Access Compliance Report

Public Rights-of-Way

(Pedestrian Signals)

| ADA ID: DB36514EB154 | Signal Type: One Push Button-Non APS | Overall Compliance: No | Severity Score: BTN 1: N/A BTN 2: N/A No BTN: N/A |

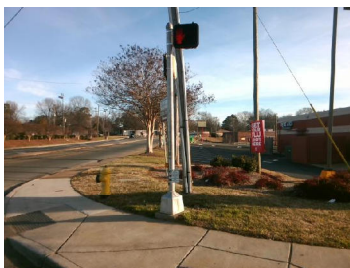
PROW/ADA: R404.2, R404.3, R404.7.2

| Compliance | Description | Data | Compliance | Description | Data |
|------------|---|---------|------------|--|------|
| No | B 1 PARA Approach Width (in) | 48.0 | N/A | B 2 PARA Approach Width (in) | N/A |
| No | B 1 Clear Floor Space Slope (%) | 2.8 | N/A | B 2 Clear Floor Space Slope (%) | N/A |

Possible Solutions: Remove and Replace Clear Space.
